CERTIFICATE OF APPROPRIATENESS

Property: 208 E 8th Street, Tracts 24B, Block 259, Houston Heights Subdivision. The property includes a historic 1,593 square foot one-story wood frame single-family residence situated on a 3,000 square foot interior lot.

Proposal: Alteration—Took off original wood siding on the west side of the house without a COA or city permits.

August 26, 2021 HPO File No. 2021_0218 208 E 8th St Houston Heights South

August 4th Site Visit

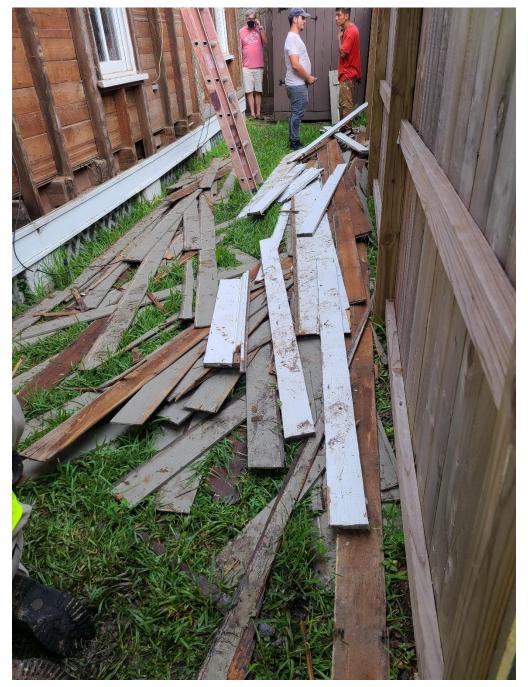
Staff instructed the applicant's father and workers to put siding inside to protect it.

Staff found the siding piled up outside and not inside as instructed before.
